Technical *Info*

Mounting instructions for CT 984 K2 and CT1015 K2, e.g. Audi, VW 2.5 TDI V6

Fig. 1

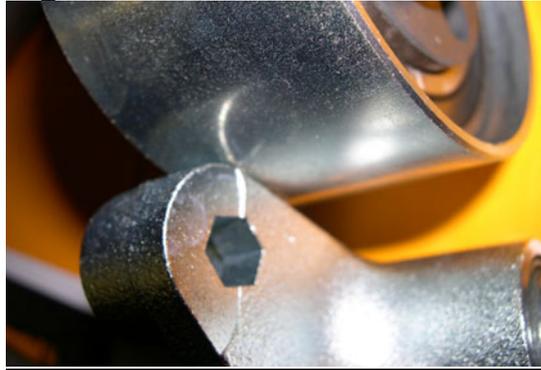
The tension lever chafes against the tensioning pulley. (Figure 1) This can result in serious damage to the engine.

Due to **improper** positioning during installation (Fig. 2), the tensioning lever comes into contact with the barrel jacket after the parts have been in operation only briefly. By way of illustration, the side facing the engine is shown here. (It is otherwise not visible.)

Carefully check the position of the tensioning lever on the check stud. Only the lever contact surface shown here (Fig. 3) must be allowed to make contact with the catch. This ensures the jacket barrel's freedom of movement.
